ACTIVATION UV LAMP

In the new release there is the option to change the activation of UV lamp.

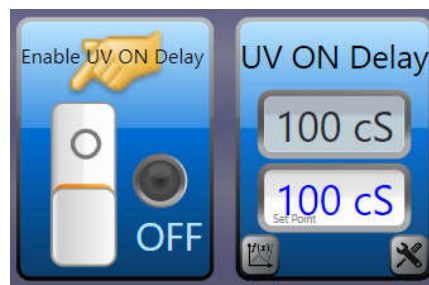
The activation can works in two way:

1. Object “Enable UV ON Delay” OFF (default)

- a. Enable: the lamp switches ON when the robot put the first bar inside the chain
- b. Disable: the lamp switches OFF when the machine will be empty

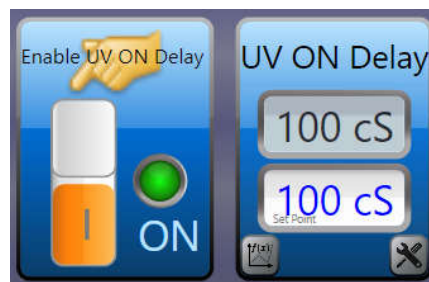
2. Object “Enable UV ON Delay” ON

- a. Enable: the lamp switches ON after the chain starts with a settable delay
The delay's value have to be write in the setpoint space of the object “UV ON Delay” the unit of measure is in cS
- b. Disable: the lamp switches OFF when the chain stops at the end of its cycle
